I. Background

In 2019, Tempe developed preliminary designs and a project assessment report to complete the gaps in these regional paths. This project will take the preliminary designs developed in 2019 and produce the final plans, specifications, and estimate so that the project can be bid for construction.

The survey was posted online from October 24 – November 7, 2022 and attendees at both meetings were directed to provide comments on the Tempe Forum. There were twenty-seven responses to the survey.

CONNECTING CROSSCUT CANAL TO GRAND CANAL

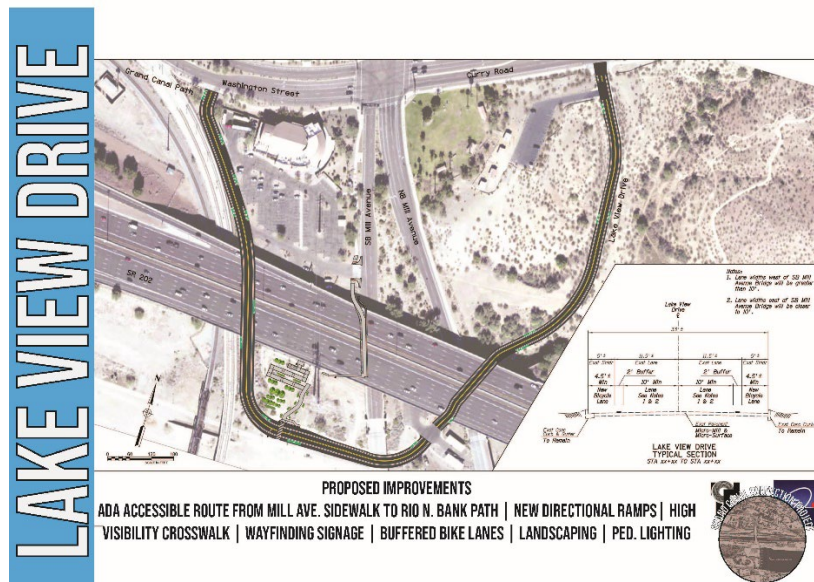
1. This is a pretty high speed area. Possibly some rumble strips before the crosswalk, and maybe offset the cross walk (like over on Hardy , south of Uni) to give a bit of refuge for peds. and the signals could be just for the southbound traffic, then for the northbound traffic, it's a pretty long distance for a slow walker/wheelchair user.

2. This will be nice for getting across Mill Ave and onto the Crosscut path.
3. Improved lighting and paving would be great!
4. Configure the crossing so users (bicyclists, especially going downhill) must slow/stop before proceeding across Mill.

6. Very much needed
7. Love this. It would be great to have the pedestrian crossing at the crosscut and Mill.
8. The major concern I have with the crossing of Mill connection for the two paths is how well it would safely work for bicyclists. As the Crosscut Canal currently ends at Mill, I have observed bicyclists shooting across Mill through traffic. My heart has been in my throat when I have seen this happen.

connection. Suggest making the pedestrian signal activate at touch to prioritize bike/ped crossing over moving vehicles fast.

14. The proposed improvements here all look great. Hope there is a lot of low water shade coverage considered in the landscaping design. A pedestrian signal is definitely needed. For anyone looking north of this signal, the next crossing is a mile away at Priest Dr.

CONNECTING RIO N. BANK TO GRAND CANAL/WASHINGTON ST.

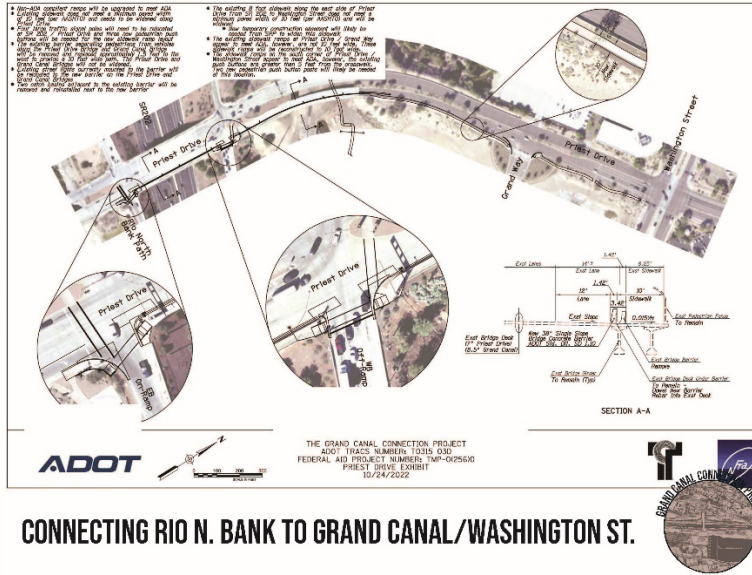
2. I always have concerns about multi-use pathway crossings at freeway off ramps. Will work be done to reduce motor vehicle traffic speeds on the ramp? Will work be done to make the crossing as visible as possible? Will right turns on red be prohibited? Will work be done make sure that vehicle drive sight lines are clear?

3. Paint is cheap and works wonders for biker visibility. I really like the proposed reconfiguration and striping at Priest & 202.
4. Make certain the sidewalk/MUP across the on- and off-ramps are visible to motorists. Tight radii

7. Long overdue
8. This would be great, especially the improvement of the pedestrian ramps. I always find the intersection of Washington and Priest tricky as there's a bike lane on priest north of washington but not south. Could this widened pathway also have a designated connection to a bike lane?

9. It should be approved. Very good for the city and its residents.
10. One suggestion I would make is to put reflectors of some sort on the concrete barriers since they will be closer to the north bound lanes.

13. Path should be wider. Consider a leading pedestrian crossing signal so people can cross without worrying about getting hit by a driver.

15. The proposed path looking north looks like the chain link fence encroaches on my biking area. Confirm height of fence will not obstruct riding path. If you are calling this a multi-use path I assume you are expecting bi-directional travel bi bike? If so, consider adding pavement marking to delineate NB vs. SB as the 10-ft space with barrier on each side is tight to have bikes going NB and SB at the same time. Was a bike lane on SB Priest considered? Priest Drive north of Washington has a nice buffered bike lane that 'dies' south of Washington where 4 SB vehicle lanes are present. 4 SB vehicle lanes has always felt excessive to me and communicates that accommodating cars is not only the top priority, but the ONLY priority. Suggest considering eliminating one of the 4 SB vehicle lanes to continue the SB buffered bike lane.
